# Change Notice

## S, LW, SW & SB Series

### Terminal Plating from Silver to Tin for Selected S Toggles, LW & SW Rockers & SB Pushbuttons

#### Terminal Surface Finish

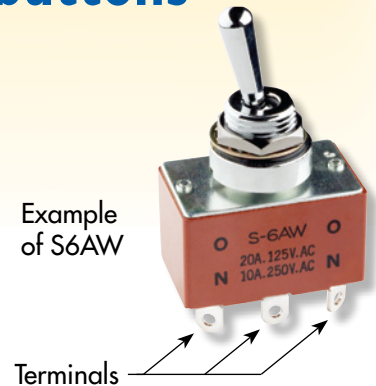
- Provides greater resistance to environmental conditions
- Inhibits tarnishing, extending storage properties

##### FROM

Anti-Tarnishing Silver (Ag) Plating

##### TO

Tin (Sn) Plating over Copper (Cu) Plating
